**Re: Haldimand County Hydro Inc.
Response to Interrogatories
EB-2011-0027**

**SUMMERHAVEN WIND LP
LEAVE TO CONSTRUCT TRANSMISSION
FACILITIES
EB-2011-0027**

**RESPONSES OF
HALDIMAND COUNTY HYDRO INC.
("HCHI")
TO THE INTERROGATORIES OF
BOARD STAFF**

NextEra - Summerhaven Proposed Transmission Line

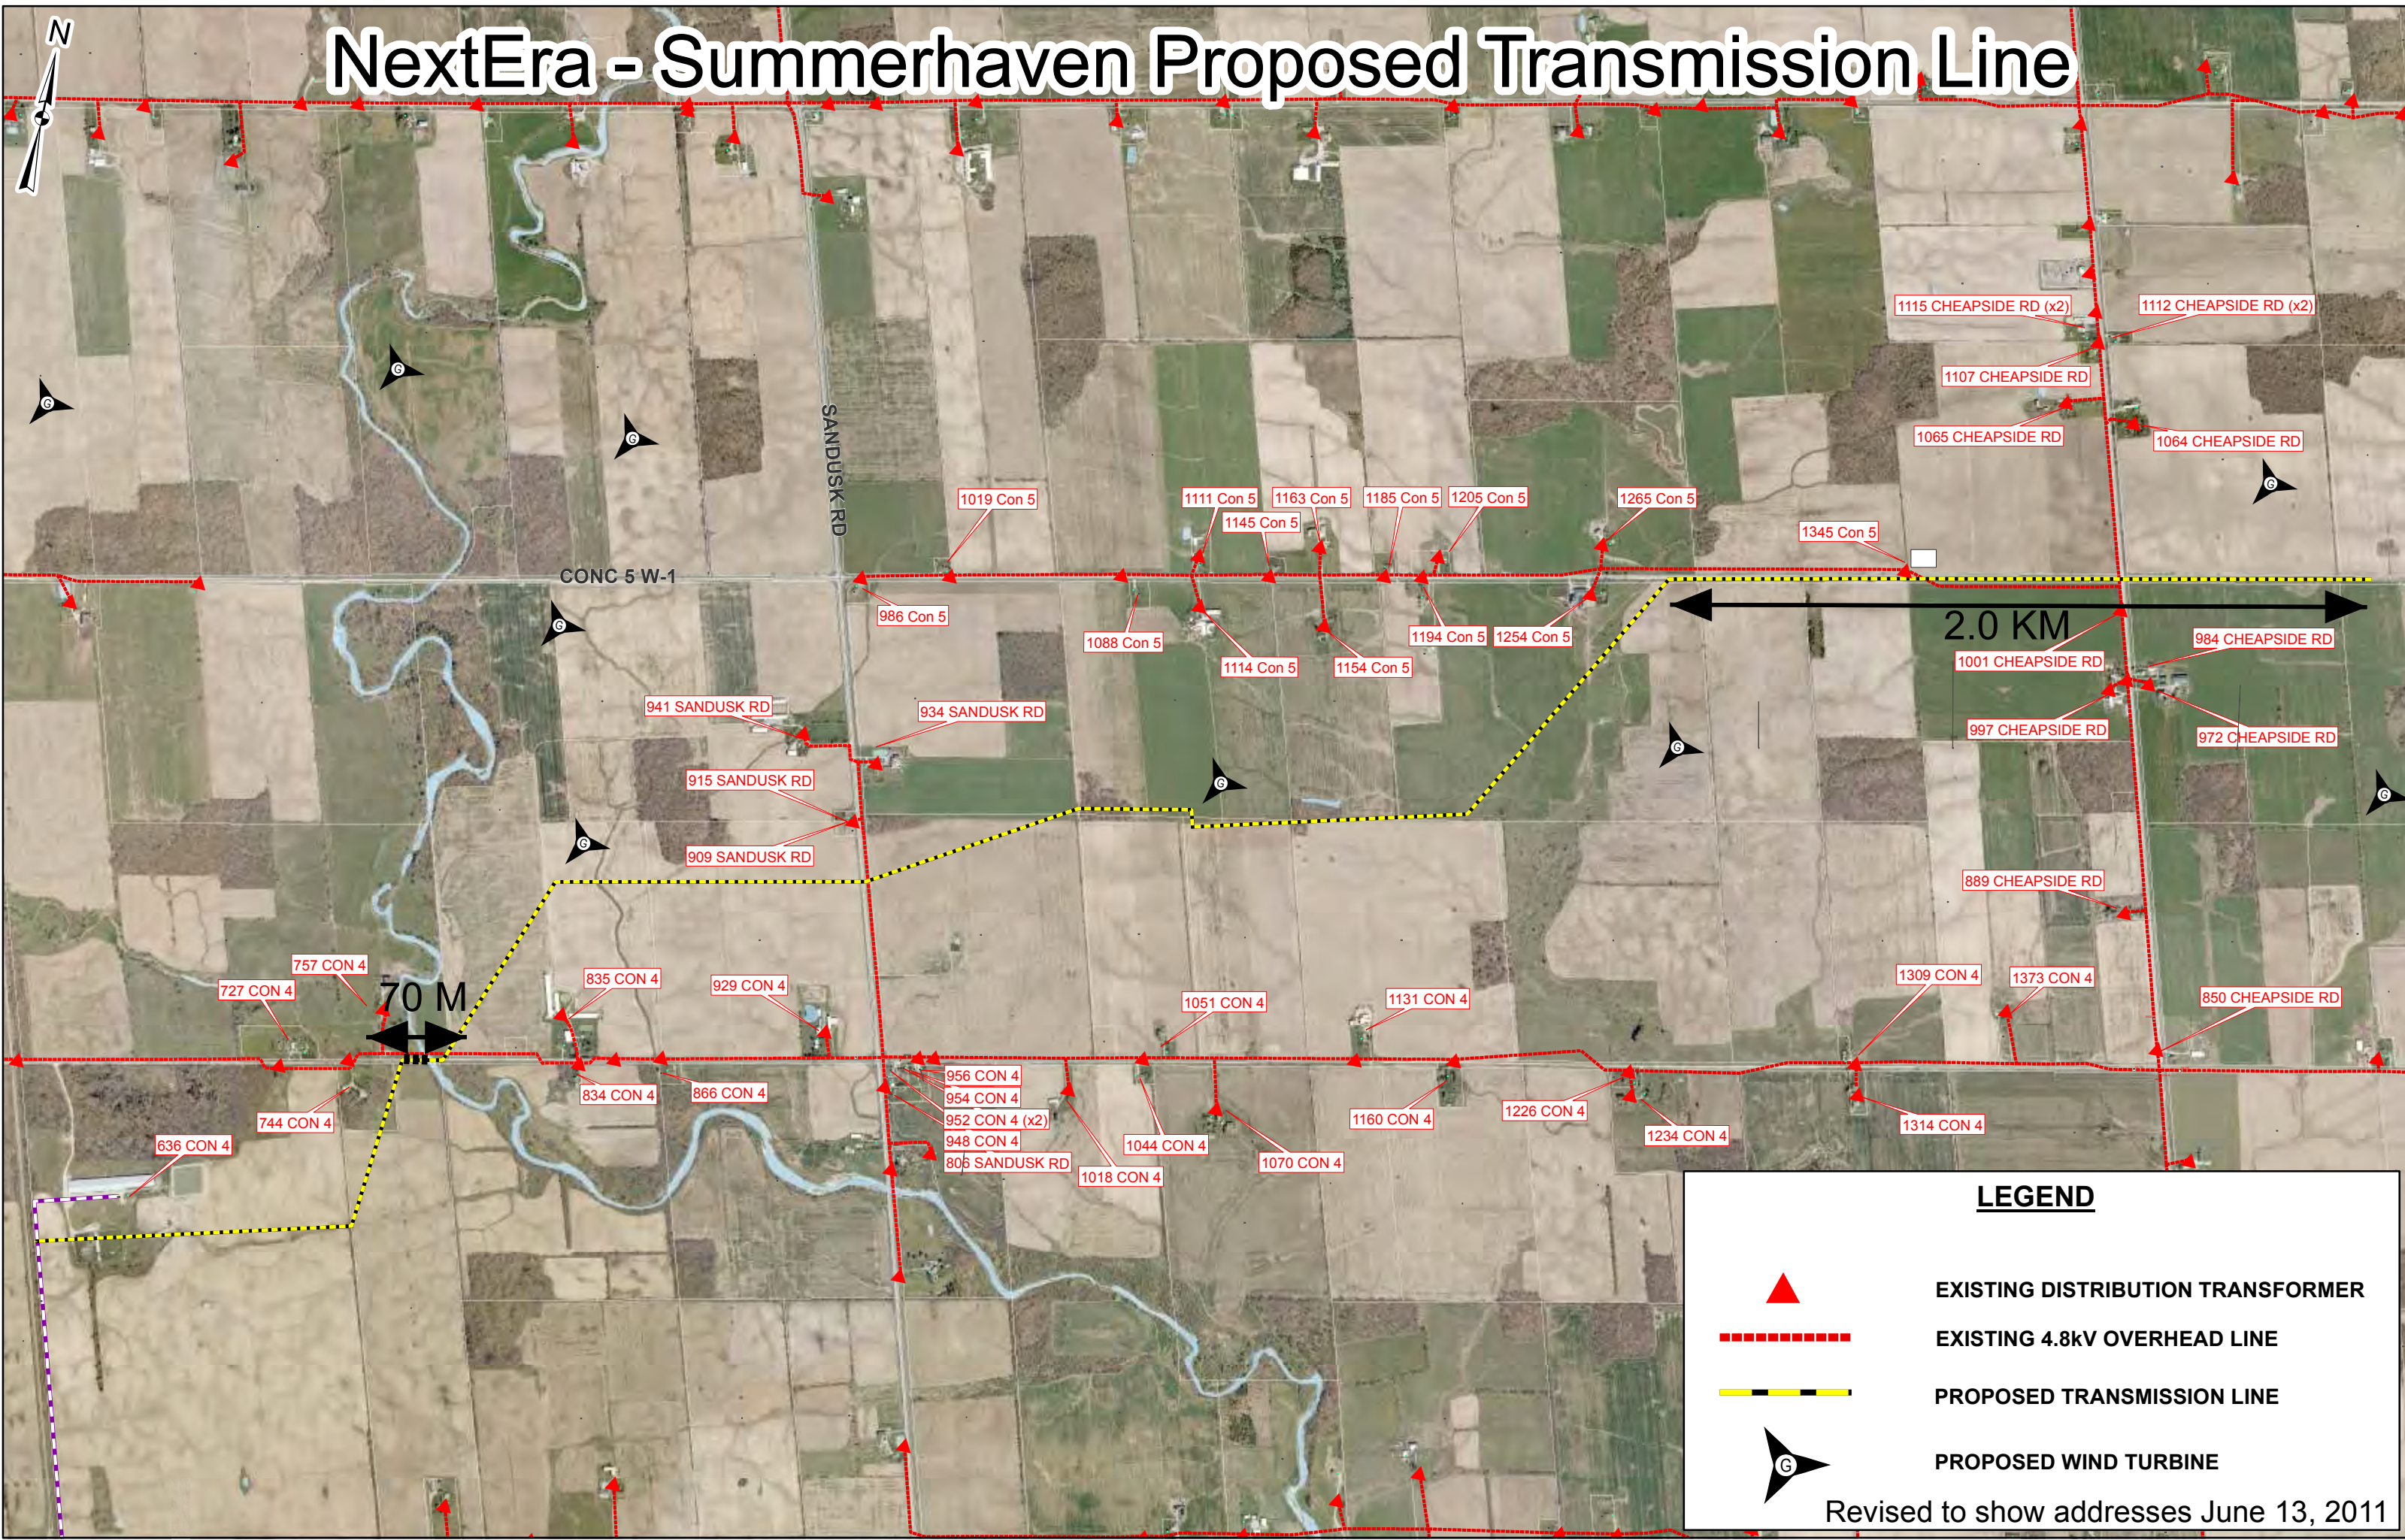
- (i) Please provide a list of the customers who have animals that can be affected due to the proposed construction of the 230 kV transmission line where it runs parallel to a HCHI's distribution line for approximately 2 kilometres on the same side of the road as shown in Reference (b).

- i) Reference (b) Kinectrics Report/Figure 3 has been modified and attached to identify all existing electric customers in the general vicinity of the proposed transmission line route. Haldimand County Hydro does not have a record of customers who have animals. We also do not know what livestock plans current or future owners of these lands may have. However, Haldimand County is an active farming community as evidenced from the following table copied from <http://www.haldimandcounty.on.ca/Business.aspx?id=978> on June 9, 2011

It also appears from Haldimand County Hydro aerial maps and/or observations driving by (fencing, equipment, hay storage, animals) that the following addresses from the modified Kinectrics Report/Figure 3 have animals:

Revised to show addresses June 13, 2011

Figure 7.1

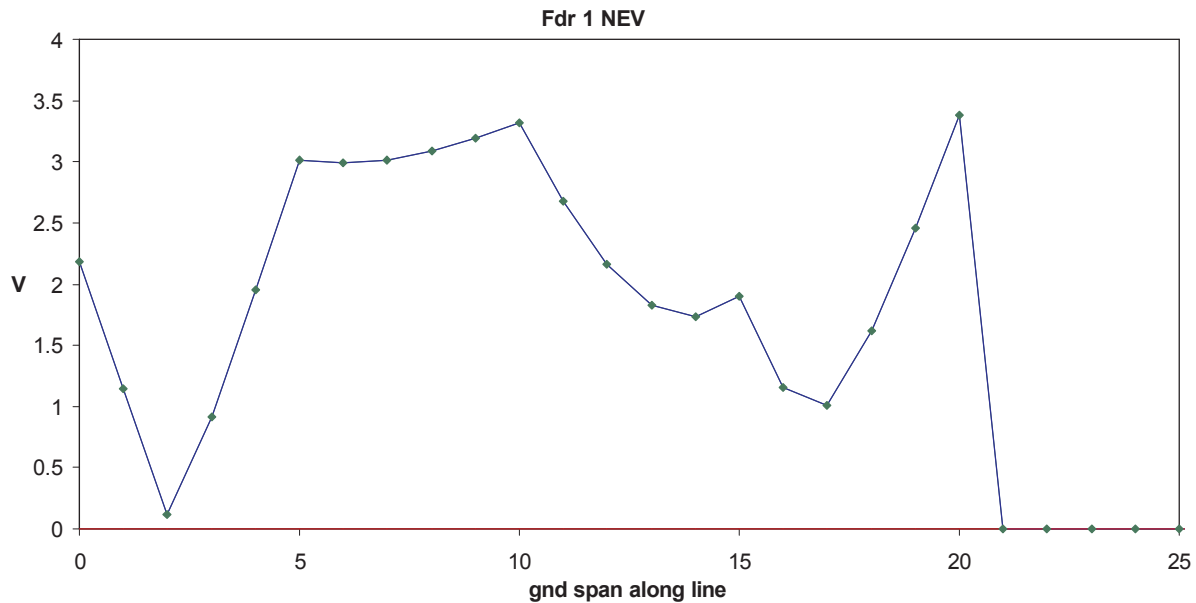
- (i) At Reference (a), the report indicated that the spread sheet software used by Kinectrics was validated against simulation software such as EMTP. Please provide a short description of the EMTP simulation.

A description of the EMTP (ElectroMagnetic Transients Program) software can be found at <http://www.emtp.com/> and includes the following summary *“The package is a sophisticated computer program for the simulation of electromagnetic, electromechanical and control systems transients in multiphase electric power systems.”*

The following distribution line configuration was simulated using both the Kinectrics spreadsheet model and the EMTP as part of a previous study:

The following table shows that very good agreement was observed. The results for the last variation are also plotted in the following figure.

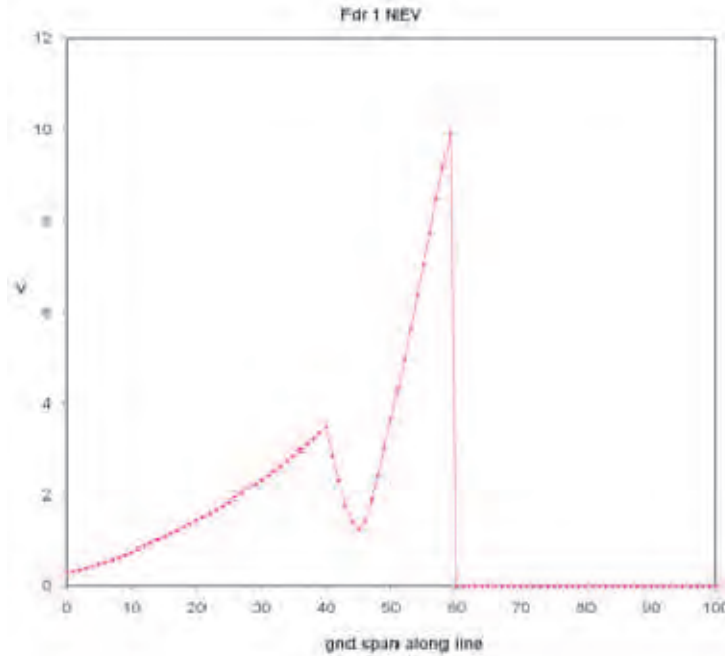
Preamble: The report concludes that the contribution to neutral potential with respect to remote earth (NEV) will remain below 7 V at respective exposure terminals for planned loading levels on the 230-kV circuit and assuming ten (10) ground-rods per kilometre, each exhibiting no more than 75 ohm resistance.

- (a) Is it true that this finding relies on the NEV profile depicted in Figure 1 maintaining a characteristic “V” shape over the exposure?
- (b) Please explicitly identify the precise assumptions giving rise to the particular shape in each of Figures 1 and 2.

- (c) The LV feeder extends an additional 2 km or so west of the paralleled section (shared use section with the 230 kV circuit) terminating on a dead end, while east of the paralleled section, the feeder continues to an extensive multi-grounded system (substantially more grounding points than west of the paralleling section). Does this affect the assumed V-shape – i.e., the NEV east and west of the paralleled section?

- (d) Is it conceivable that these assumptions could be violated in time due to possible changes to the existing feeder configuration, including the possible interconnection of this feeder's neutral to those for adjacent (future) supply circuits? In this context, how might the predicted NEV profile and values change under less favourable circumstances?

- (a) The “V” shape in Figure 1 arises because only the magnitude of potential is plotted (phase angle is ignored) and the exposure is only 2 km long. The two peaks actually have opposite polarities, with the difference equal to the longitudinal induction. Over this short distance, the shunt resistance of all pole and service grounds is high compared to the self impedance of the neutral and they have little effect on the potential.
- (b) For the longer 20 km study, the “V” becomes a “U”. Over this longer distance, the shunt resistance of all pole and service grounds is comparable to the self impedance of the neutral. This reduces neutral potentials midway along the exposure.

- (c) The 2-km study assumed the neutral continued 4 km beyond the exposure section at each end. Removing the 4 km at the far end would increase the neutral potential to 9.9 V at the far end as shown in this plot (for 37.6 ohm pole and service grounds on a 100 m span):

- (d) Yes, as a worst case, the entire longitudinal potential of 13 V could appear at one end of the exposure
